<b>CITY OF WESTMINSTER</b>			
<b>PLANNING APPLICATIONS COMMITTEE</b>	<b>Date</b> 28 March 2017	<b>Classification</b> For General Release	
<b>Report of</b> Director of Planning		<b>Ward(s) involved</b> West End	
<b>Subject of Report</b>	<b>17 Adams Row, London, W1K 2LA,</b>		
<b>Proposal</b>	Demolition behind retained front facade and redevelopment to provide a building comprising new basement, ground and two upper floors, including rear extensions at ground and first floors, and 1st floor rear terrace, for use as a single family dwelling with two integral garages.		
<b>Agent</b>	De Matos Ryan		
<b>On behalf of</b>	Alexanders Ltd.		
<b>Registered Number</b>	16/12217/FULL	<b>Date amended/ completed</b>	11 January 2017
<b>Date Application Received</b>	22 December 2016		
<b>Historic Building Grade</b>	Unlisted		
<b>Conservation Area</b>	Mayfair

**DRAFT DECISION LETTER**

**Reference:** 16/12217/FULL

## 10. KEY DRAWINGS

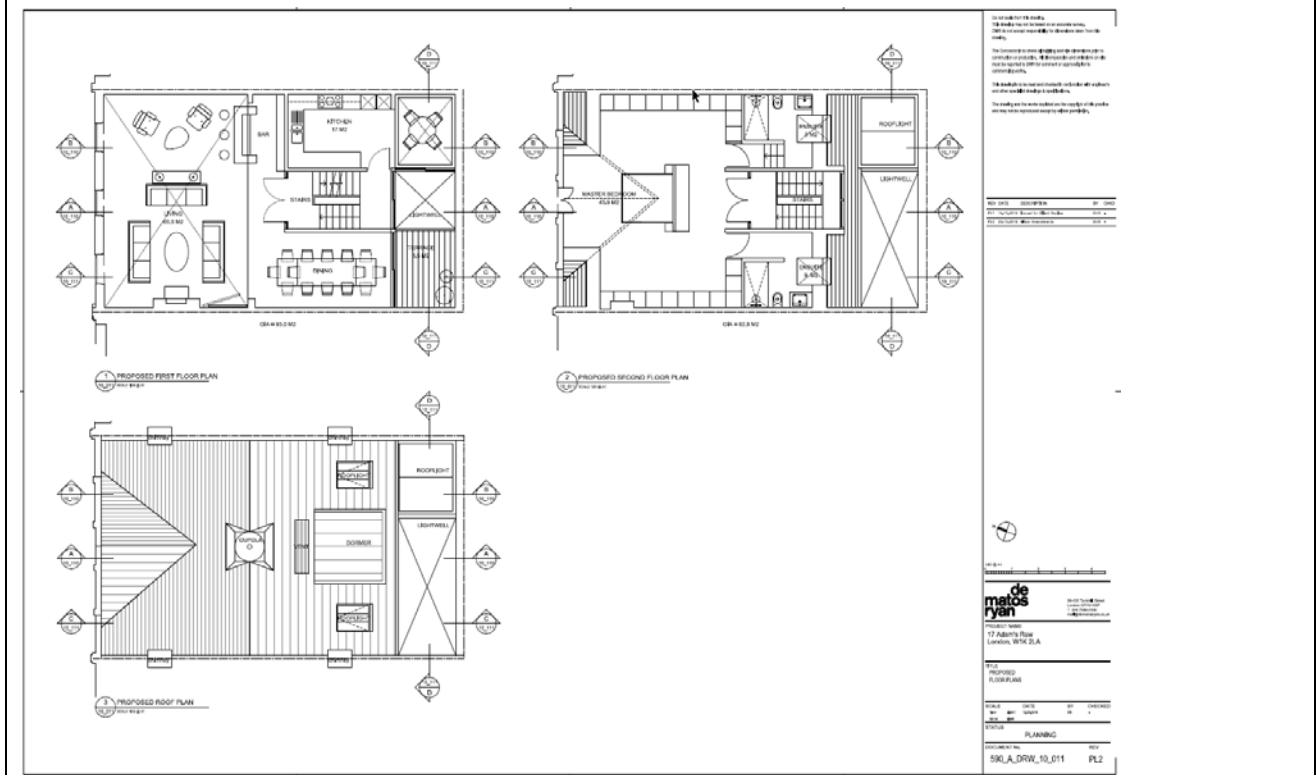
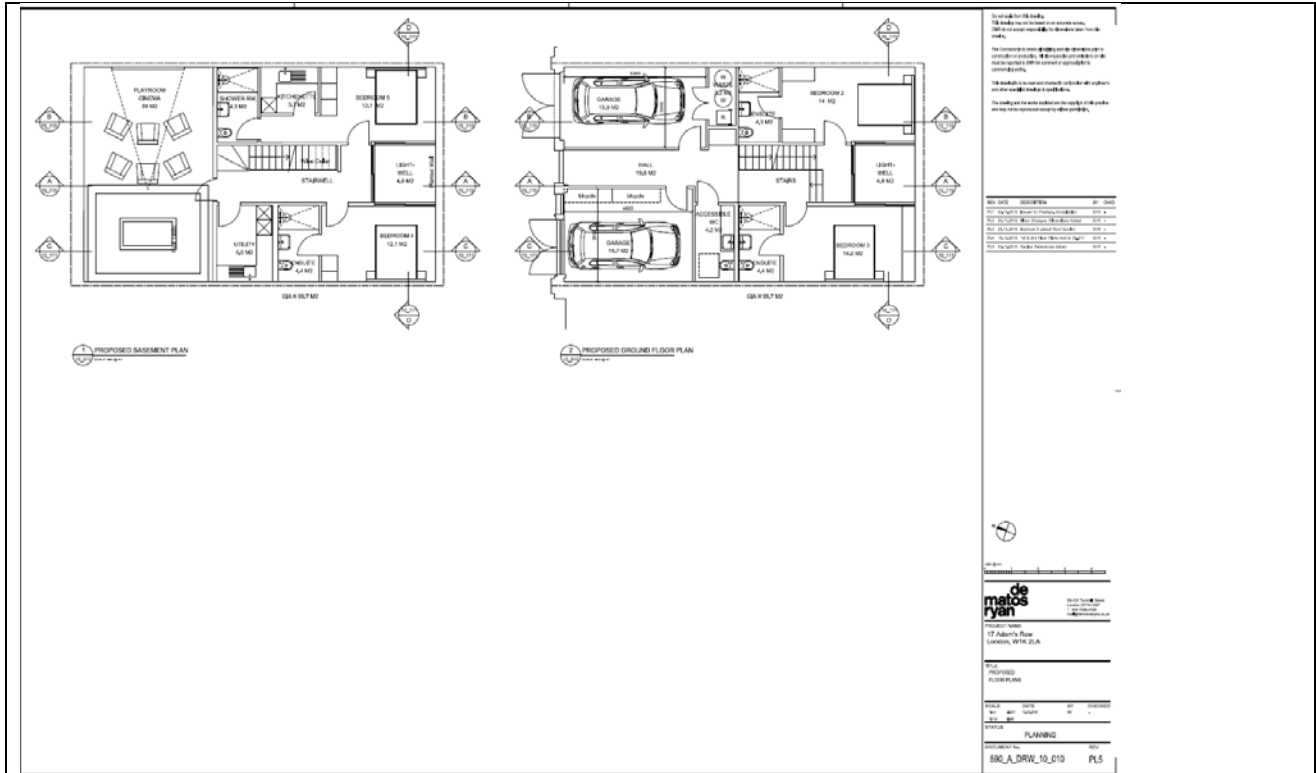
The key issue at the rear is the loss of the large and small dormer in the rear roof slope. The other changes to the rear elevation are considered to have less impact on the appearance of the building because of the height of the rear party wall, which rises almost to eaves level.

The current arrangement of dormers does have some charm, its asymmetry is a deliberate device, repeated at no 18 next door. It is not however considered that

there is sufficient consistency of rear dormer arrangements along Adams Row for this to form a reason to resist the loss of the dormers. The proposed arrangement of windows and rooflights is considered to be sufficiently traditional for this, relatively sensitive, context.

A markedly modern central dormer was originally proposed, along with a frameless glass opening to the rear terrace. Both these elements have been redesigned in more traditional materials and design to better reflect the style and period of the host building. These elements are now considered to be acceptable.
